ARAPAHO ROAD PHASE III
 PLAN & PROFILE
STORM SEWER 'B' STA. 5+00 TO STA. 10+00

TOWN OF ADDISON

g&a Grantham & Associates, Inc. SHT. SW-13
 1919 S. SHILOH ROAD, SUITE 310, L.B. 8 GARLAND, TEXAS 75042 (972) 864-2333 (TEL) (972) 864-2334 (FAX)

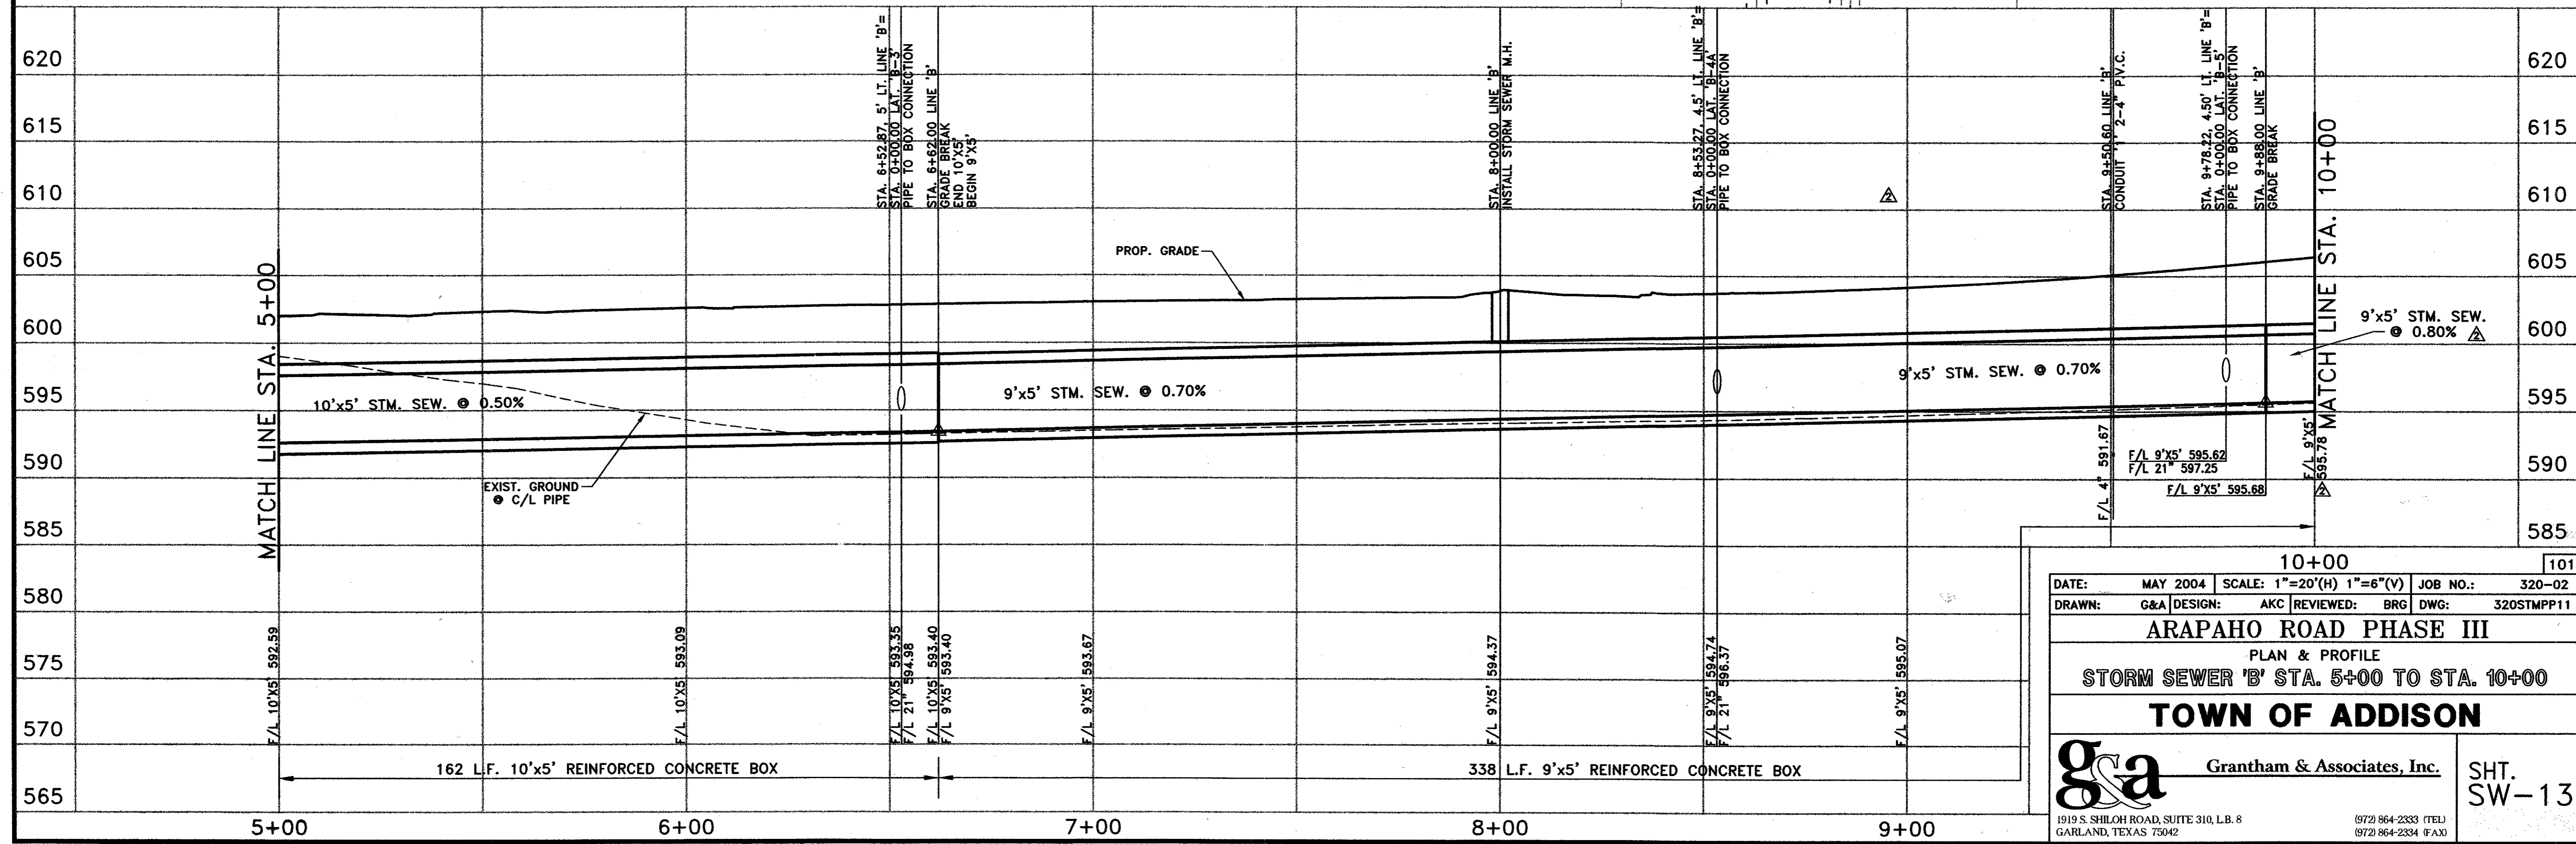
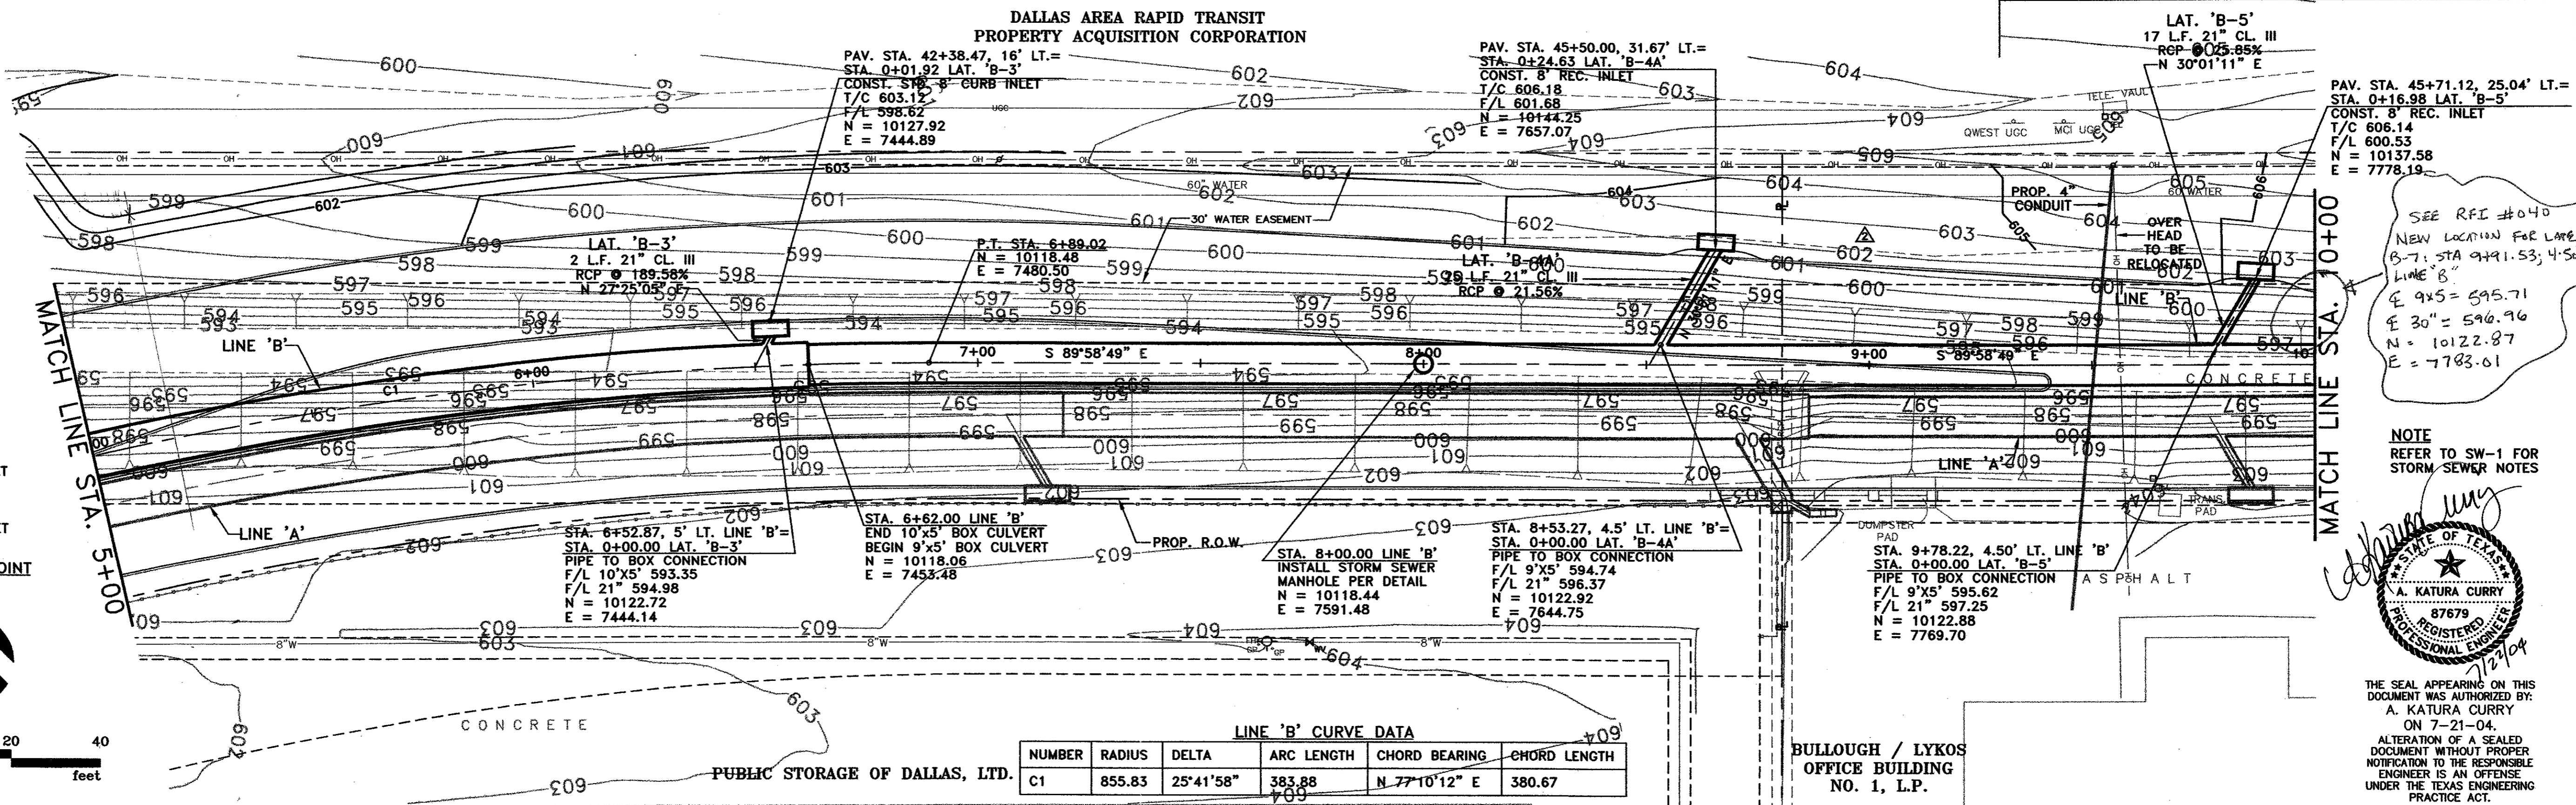
SEE RFI #040
NEW LOCATION FOR LANE 24 L
B-7: STA 9+91.53; 4.50' LT.
LINE 'B'
E 9'x5' = 595.71
E 30" = 596.96
N = 10122.87
E = 7783.61
